Oyster Creek Generating Station
Facility Operating License No. DPR-16
NRC Docket No. 50-219

Subject: Response To Request For Additional Information – License Amendment
Request No. 315, “Application of Alternative Source Term” (TAC No. MC6519)

LICENSE AMENDMENT REQUEST No. 315

APPLICATION OF ALTERNATIVE SOURCE TERM

Figure 1

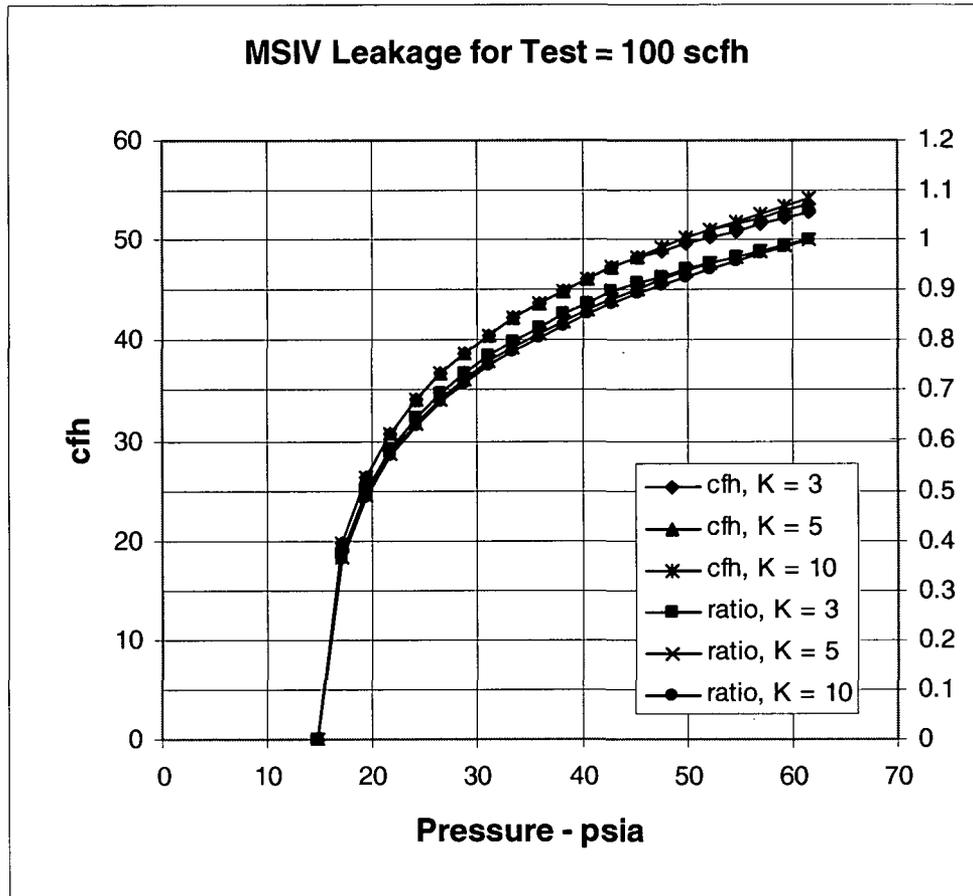
2. RG 1.183 Position 4.5 states that technical specification values should be used. Position 6.2 states a similar position for the main steam isolation valves. Given that secondary bypass leakage rate is calculated as a function of pressure:
 - a. Provide justification that leakage through narrow, ill-defined clearances that may change with pressure, like the stem and seat areas of valves, can be modeled as isentropic nozzles.

It is technically the case that the ratio of accident flow to test flow would be weakly affected by the assumption of a specific flow resistance. This effect is shown in the following study of Main Steam Isolation Valve (MSIV) volumetric flow vs. pressure with resistance as a parameter for a given mass flow at test conditions (100 scfh):

The plotted ratio in Figure 1 (right-hand vertical axis) is that of volumetric flow at 61.6 psia (the peak accident pressure for the case studied – not Oyster Creek) to volumetric flow at a given pressure less than the peak accident pressure. One can see that the ratio is not greatly affected by the assumed head loss coefficient, K; and this observation tends to confirm the assumption that any specific value of assumed flow resistance would not produce ratios of accident flow to test flow greatly different from another. (Note that the head loss coefficient for an isentropic nozzle is effectively zero since all velocity head is recovered. While that case was not specifically included in this study, the trend of the study is clear: lower flow resistances tend to create slightly greater ratios of accident flow to test flow for pressures less than the test pressure. This means that for Oyster Creek, the assumption of an isentropic nozzle tends to result in slightly higher containment leakage rates as the containment pressure decreases than would be the case for $K > 0$. However, in any case, the effect is small.)

Figure 2

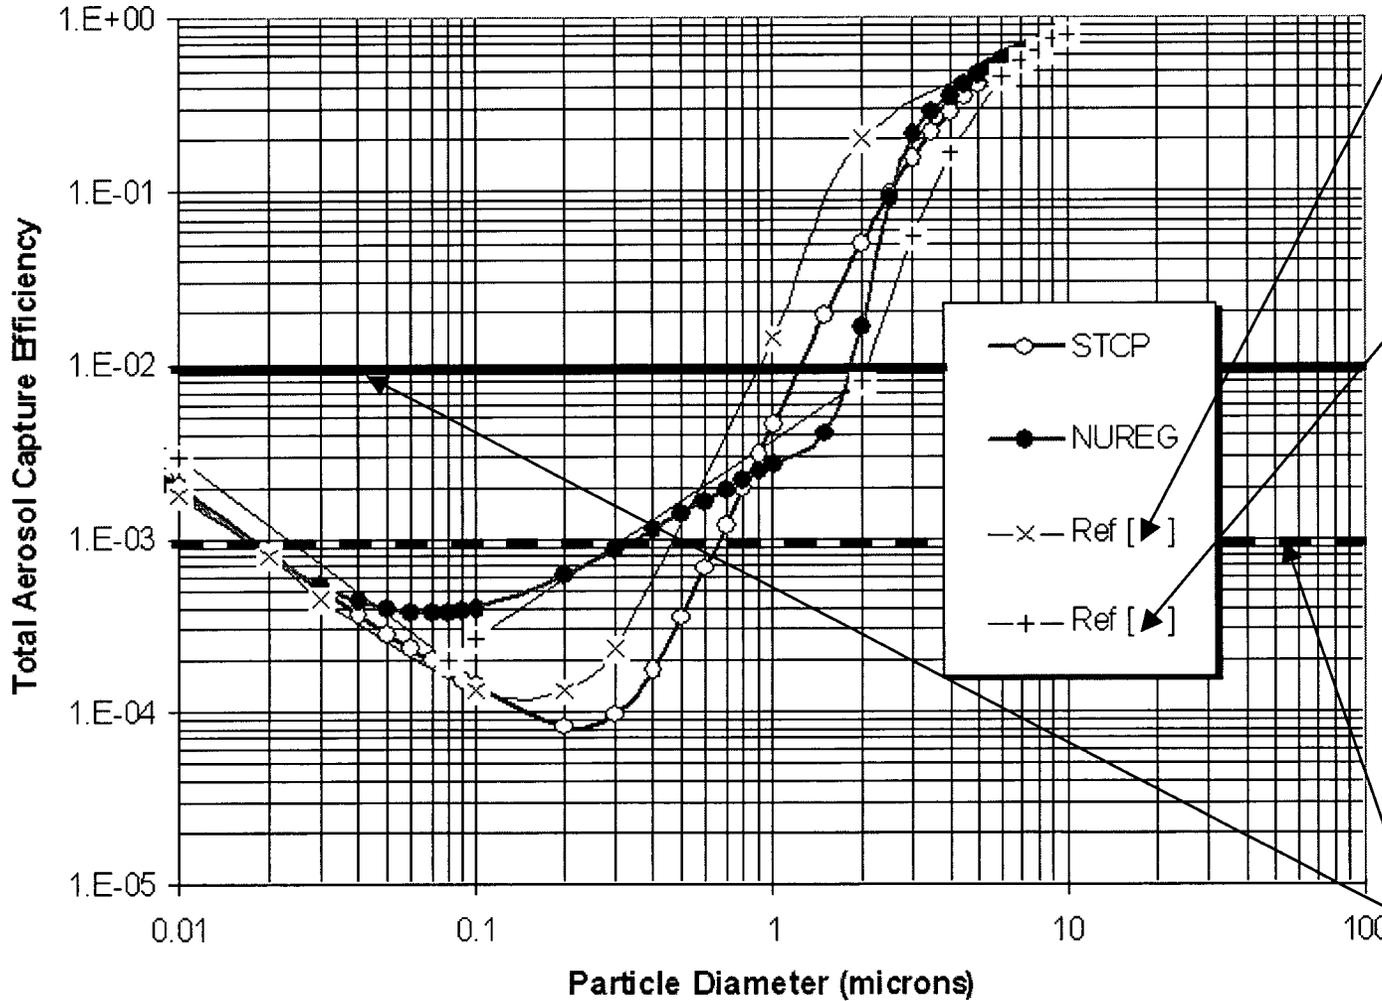
4. With regard to the assumptions for drywell iodine removal:
 - a. Justify the use of the STARNAUA removal models for this application. One way that would be acceptable to the NRC staff would be to compare STARNAUA to the models referred to in RG 1.183 as acceptable spray removal and natural deposition models.

The difference between STARNAUA and SRP 6.5.2 is in the quantification of E/D. As noted above, the E/D is conservatively estimated to be 10 per hour (1% efficiency for a one mm drop) until 98% of the mass has been removed and then one per hour (0.1% efficiency for one mm drop) after that. The removal efficiency calculated rigorously by STARNAUA is similar as seen on Figure 2.

In Figure 2, both STARNAUA modeling options (STCP and NUREG) are presented. The NUREG option is preferred and has been exercised for Oyster Creek. Figure 2 shows the removal efficiency for particles of different sizes. It may be noted that for sub-micron particles, the rigorously calculated removal efficiency may be substantially lower than 1% and even 0.1% (the removal efficiencies used for the SRP 6.5.2 model). The key, therefore, is having an accurate estimate of the size distribution of the airborne particulate.

STARNAUA Spray Droplet Efficiency for 1000 um Droplet Compared to SRP 6.5.2
